ADA Curb Ramp New Construction Inspection Form (Perpendicular)

Nw Kaye

24952.54

NW King

PERPENDICULAR RAMP (PR)

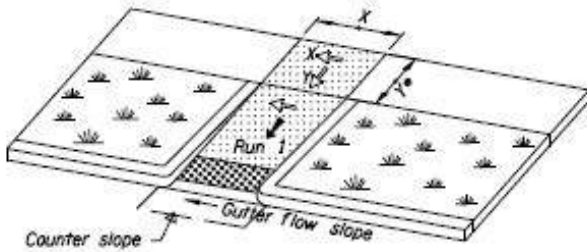
RR1 ICRR
